CoreLink™  
DDR2 Dynamic Memory Controller (DMC-341r1)  
**Errata Notice**

This document contains all errata known at the date of issue in releases up to and including r1p0 of PL341 AXI DDR2 Dyn Mem Ctrl, and revision r1p1 of DMC-341 AXI DDR2 DYN MEM CTRL

**466779: DDI0418B DDR2 DMC (PL341) r0p1 TRM - Figures show incorrect timing****Status**

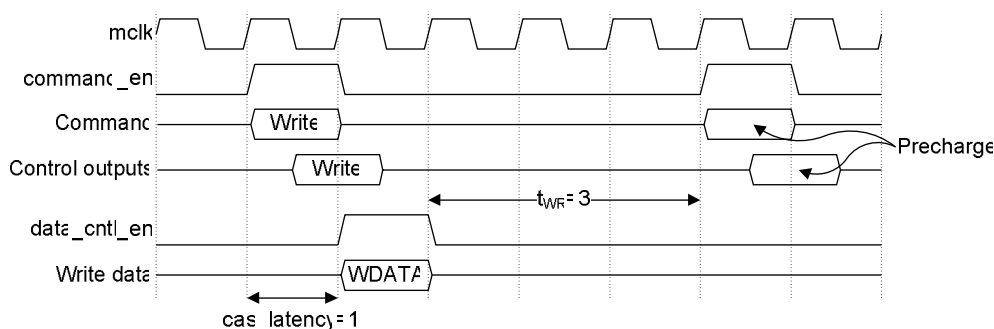
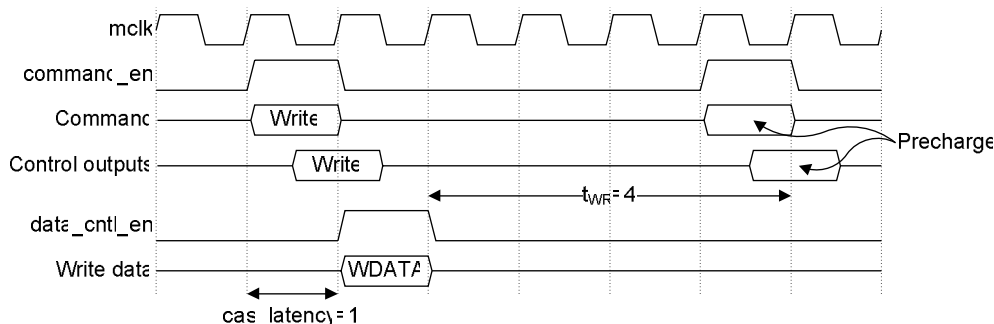
Some of the timing diagrams in the the Technical Reference Manual do not show correctly how a timing parameter is applied.

The numerical value shown for the timing paramater does not correspond with the timing of the signals shown in the diagrams. In each case, the numerical value should be one higher than the timing shown, and the arrow should be extended to the next rising clock edge.

For example the existing diagram Figure 2-19:

Should be displayed as:
